**HORIZONTAL DIRECTIONAL DRILL ANALYSIS
WETLAND J-47 CROSSING
PADEP SECTION 105 PERMIT NO.S: E22-617; E38-194
PA-LE-0001.0000-SR-16
(SPLP HDD No. S3-0090-16)**

This reevaluation of the horizontal directional drill (HDD) installation of a 16-inch diameter pipeline that traverses under Wetland J-47, and Streams S-A48, S-K23, and S-K17 has been completed in accordance with Stipulated Order issued under Environmental Hearing Board Docket No. 2017-009-L (Order). During drilling of the first HDD for installation of the 20-inch diameter pipeline, inadvertent returns (IRs) to the land surface occurred as the pilot drill was progressing toward the exit, with the first IR occurring 140 foot (ft) before exiting. Due to these IR events the second HDD requires reevaluation in accordance with the Order.

REDESIGNED HORIZONTAL DIRECTIONAL DRILL DESIGN SUMMARY: 16-INCH

REVISED (POST 20-INCH) HORIZONTAL DIRECTIONAL DRILL DESIGN SUMMARY: 16-INCH

**SEPTEMBER 2017 16-INCH HDD PLAN AND PROFILE
NOVEMBER 2018 2ND REVISED 16-INCH HDD PLAN AND PROFILE**

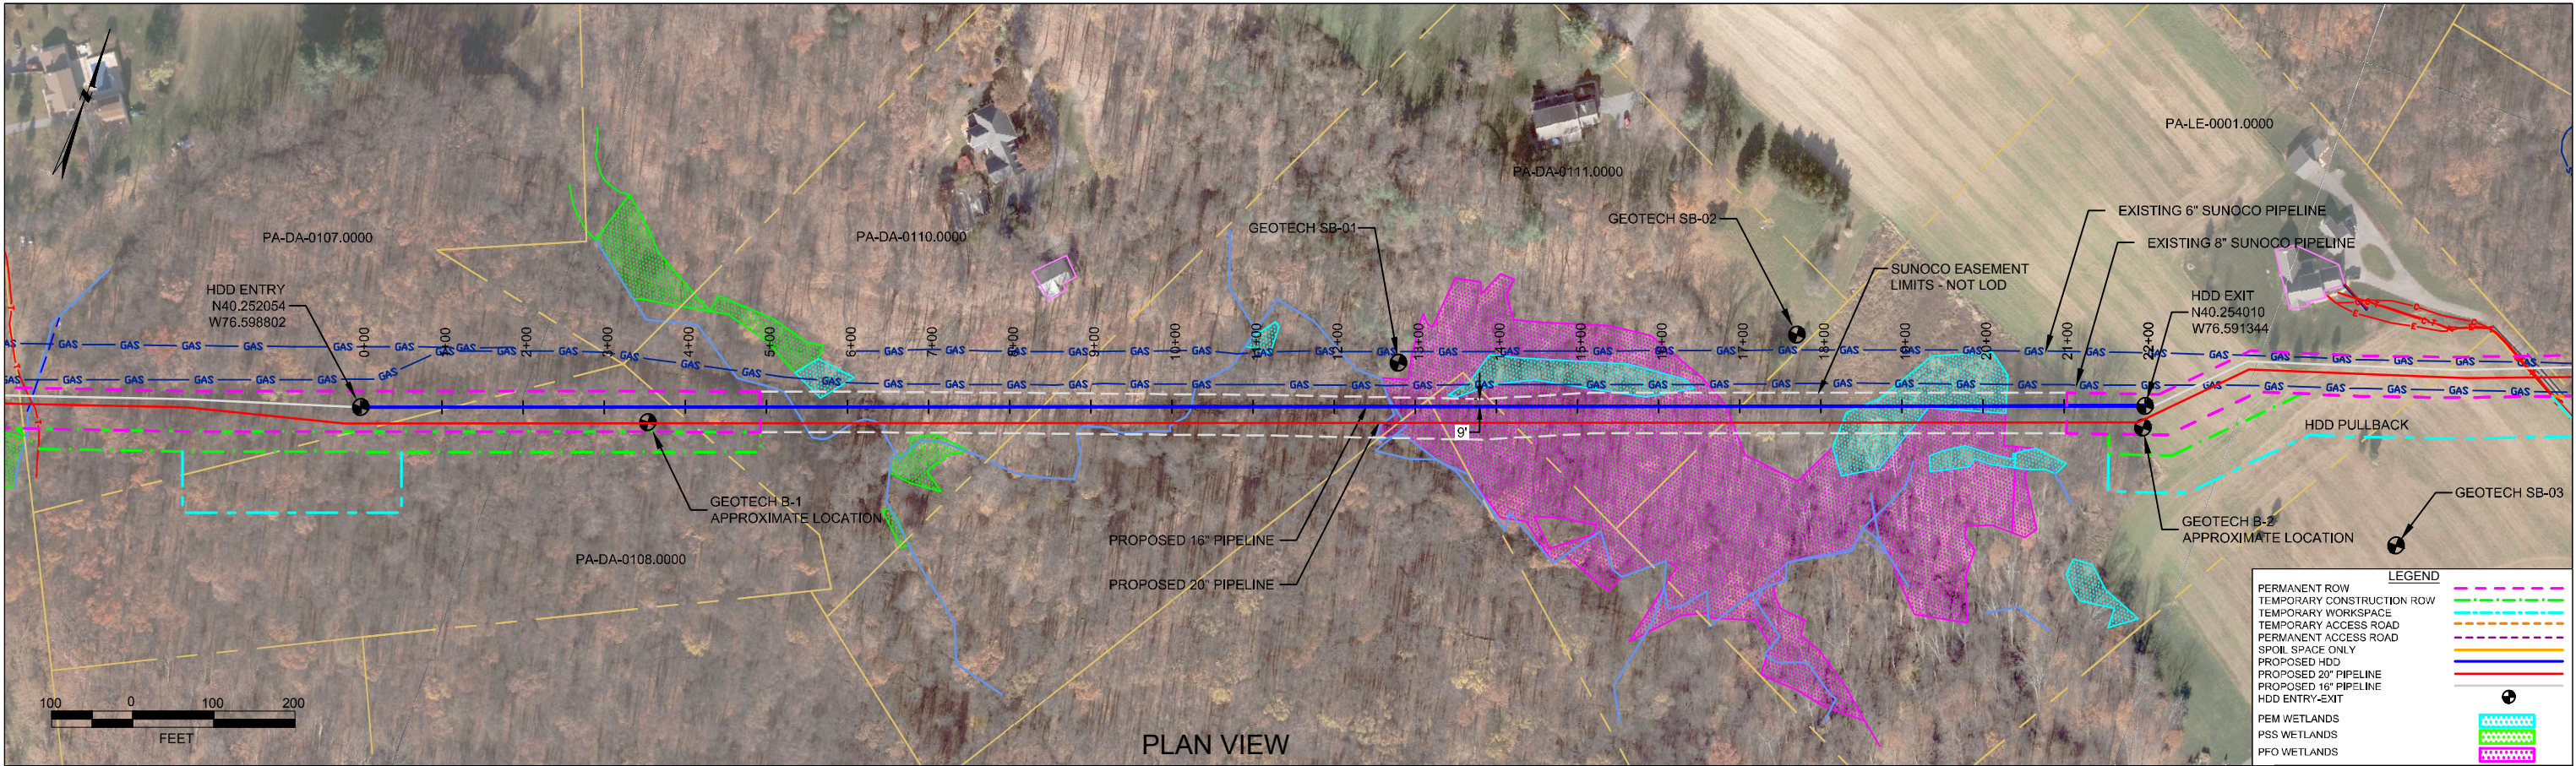
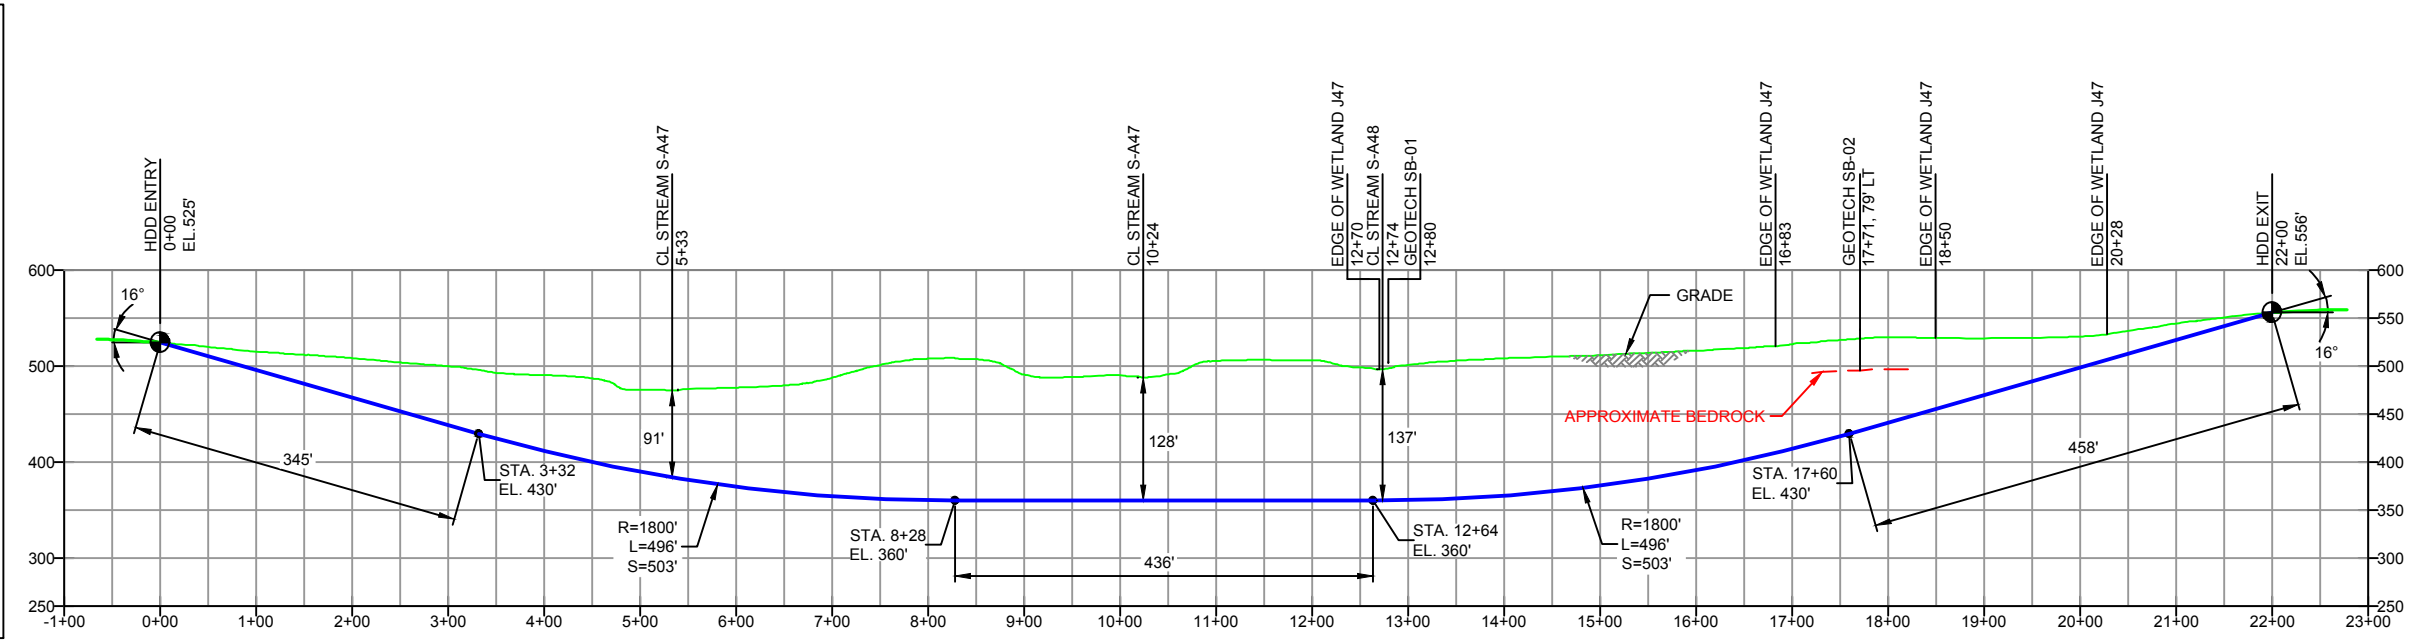
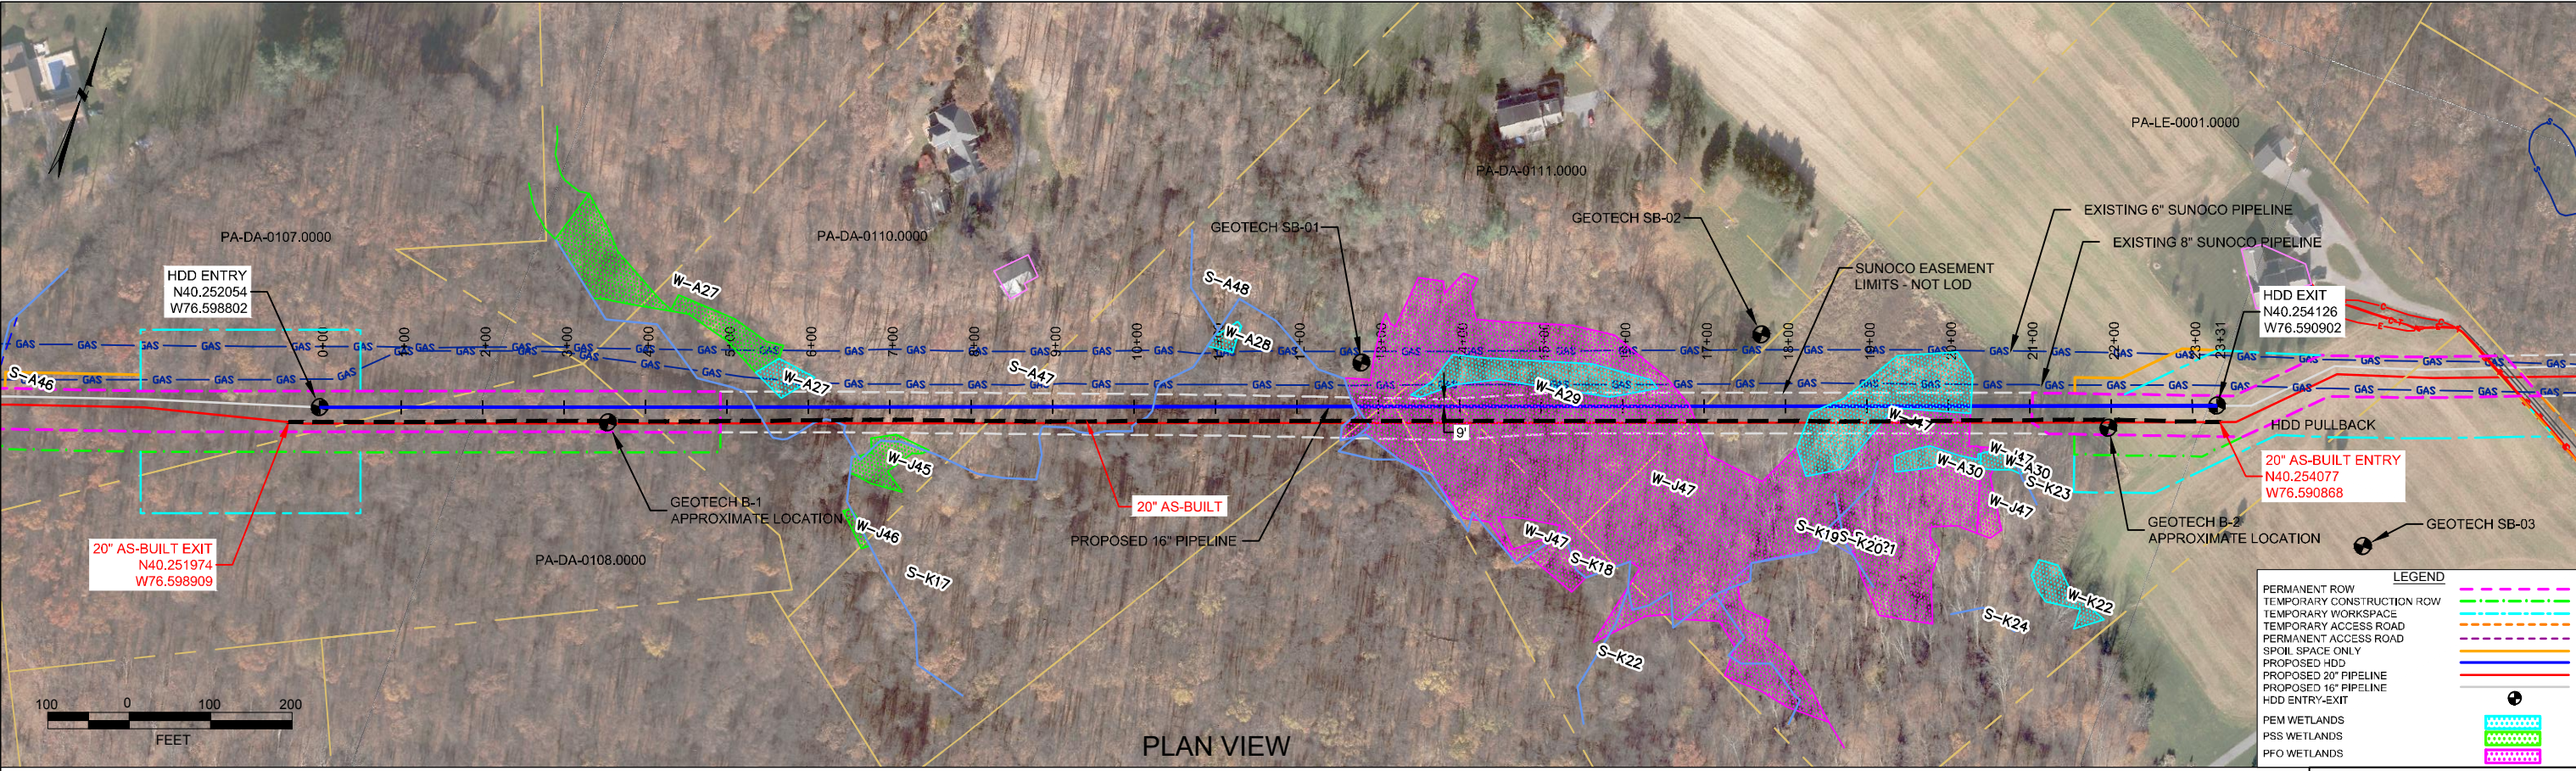
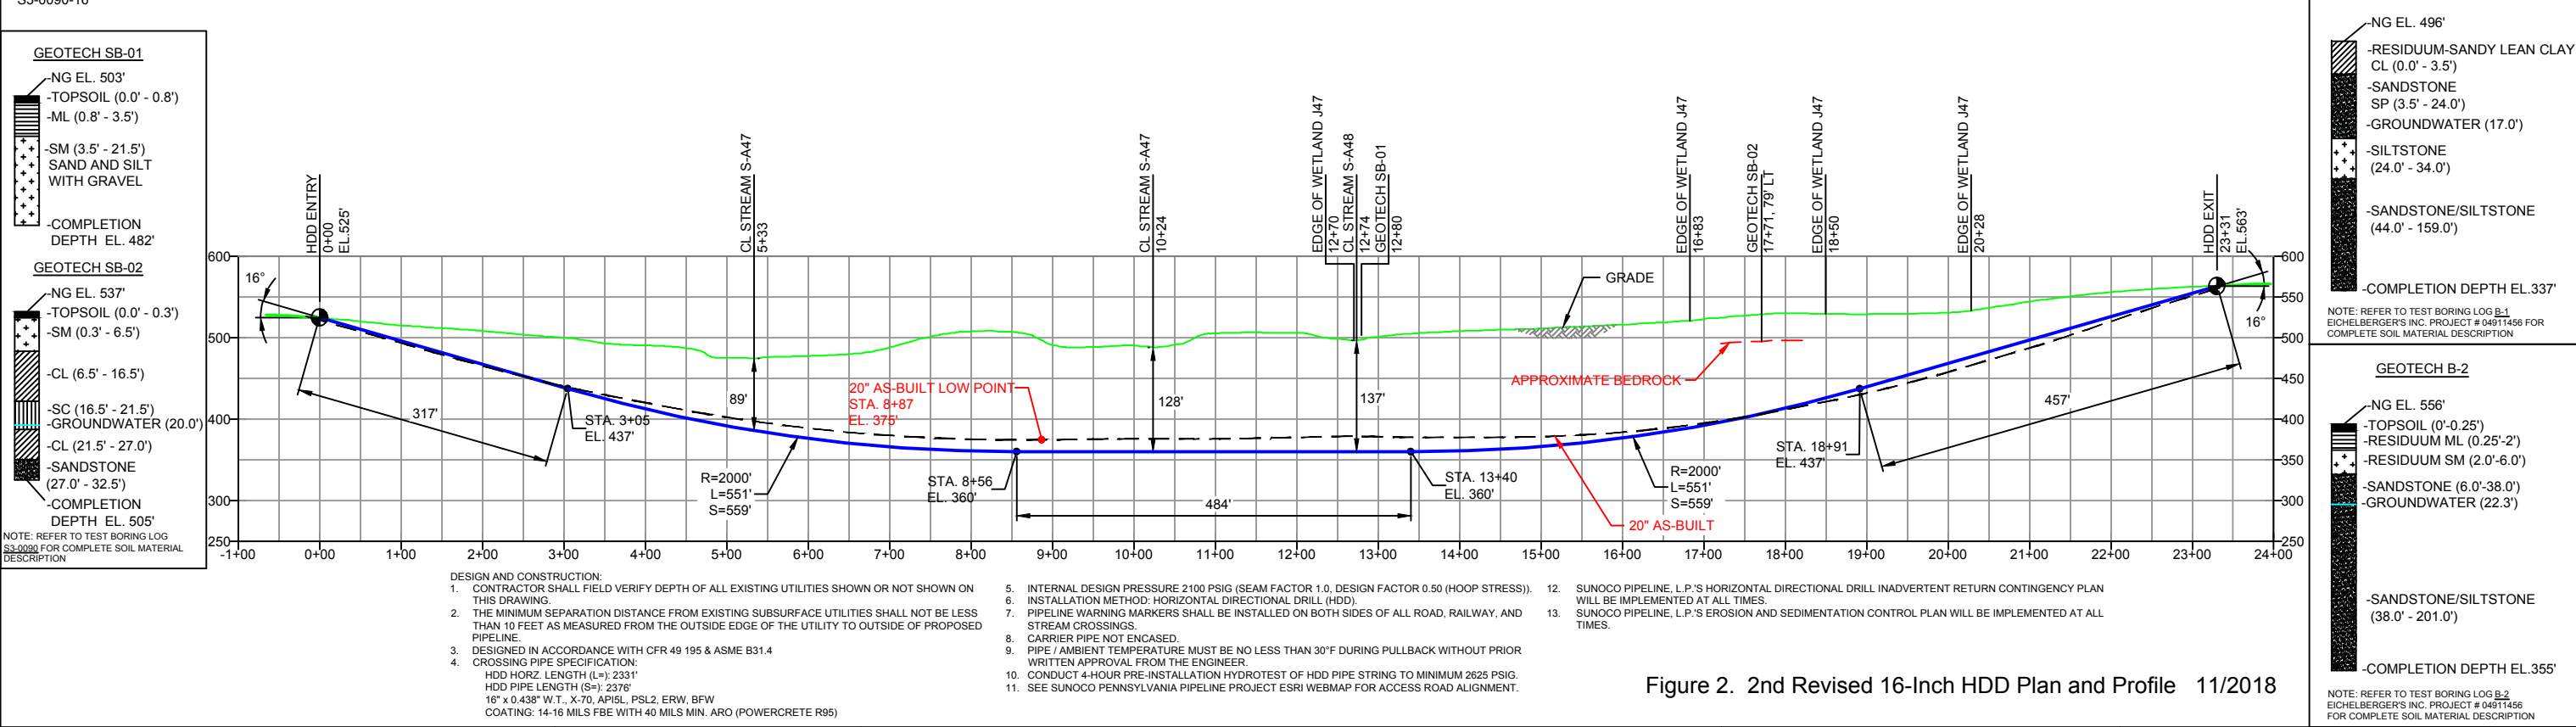
The root cause of the IRs was determined to be the shallow proximity of the HDD profile parallel to the land surface in the last 150 ft of the profile. To achieve greater depth below ground for the pilot hole drilling, an intercept profile was designed with a revised HDD entry point established 150 ft east of the original exit point, and new easement and surface workspace was acquired for the HDD redesign. The 150-ft setback and increased angle of the intercept entry point allowed the pilot HDD to advance more rapidly into intact bedrock and eliminated the IR occurrences. No IRs during drilling of the revised intercept profile.

A matching revision and setback is proposed for drilling and installation of the 16-inch pipeline. The weakest point in the original profile is within the first 400 ft of the beginning and end of the drill. The revised design profiles provide for a maximum of 119 ft of cover above the 16-inch pilot drill, and greater than 58 ft depth of cover where IRs previously occurred.

Additional geologic investigations were completed and utilized in the designs presented in the October Reevaluation Report for these HDDs. As a result of the events occurring during drilling and installation of the 20-inch pipeline, the 16-inch HDD was redesigned to approximate the profile of the field revised 20-inch pipeline. A summary of the redesign factors is provided below. The Original Reevaluation and Post 20-Inch Redesigned HDD plan and profiles are provided in Attachment 2.

As shown on Figure 2 the 2nd revised HDD profile for the 16-inch pipeline is 131 longer, with a depth of cover at the IR locations increased by 41-47 ft, and designed for a sharp and quick entry and exit from the horizontal depth.

- Horizontal length: 2,331 ft
- Entry/Exit angle: 16 degrees
- Maximum Depth of cover: 137 ft
- Change of depth at the 20-inch IR locations: 41-47 ft
- Pipe design radius: 2,000 ft
